## **IFB No. 24-002 Dykes Road Piping - Federal Grant Funded ARPA Project**

### **Addendum #2**

Addendum based on South Broward Drainage District (SBDD) Permitting Comments  
– **Reference attached updated Plan Sheets**

## FABRIC FORM REVETMENT DETAIL

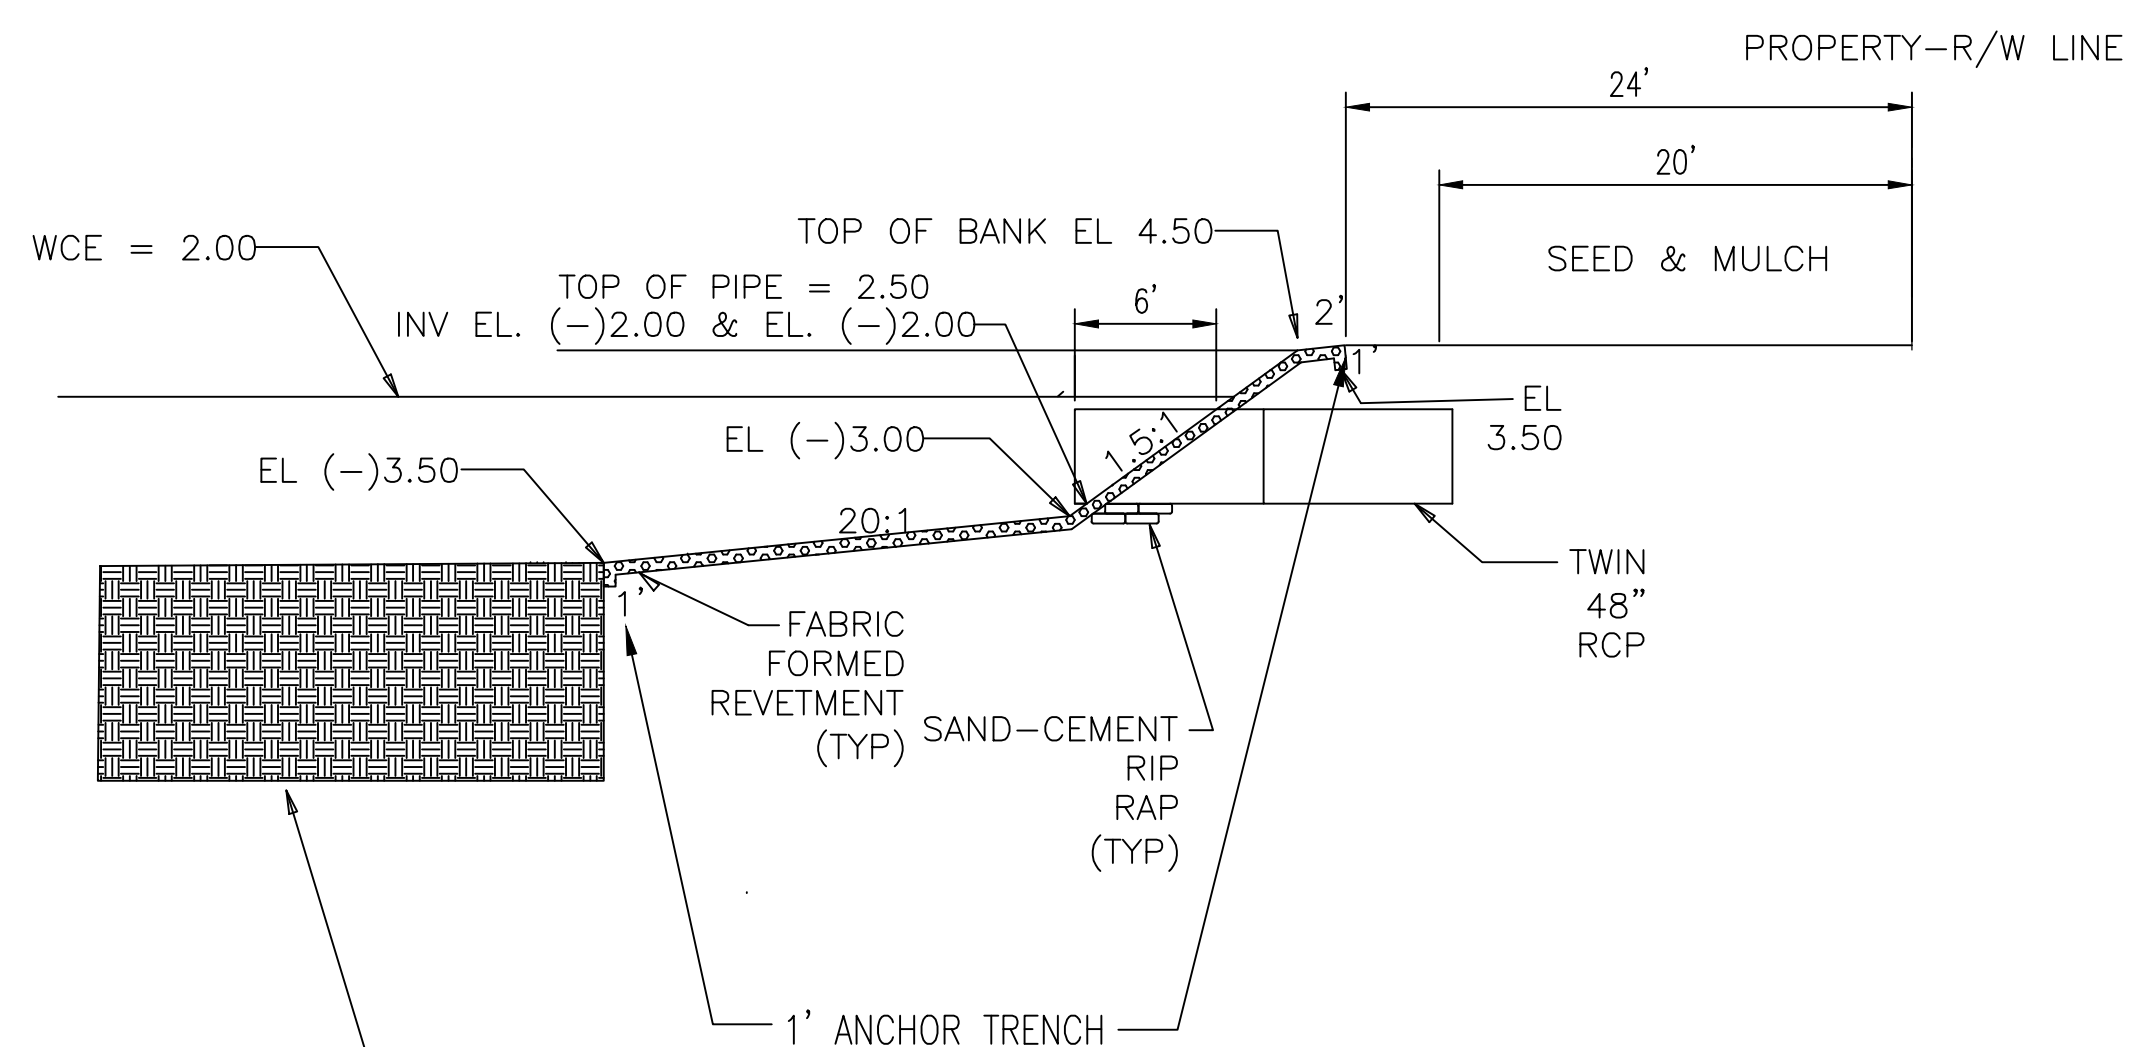
2. SBDD Comment: On the Fabric Form Revetment Detail, the invert for the twin 48" RCP culverts should be consistent at (-)2.00'. Label the anchor trench.  
R: Please refer to the revised Detail sheet C-6.0
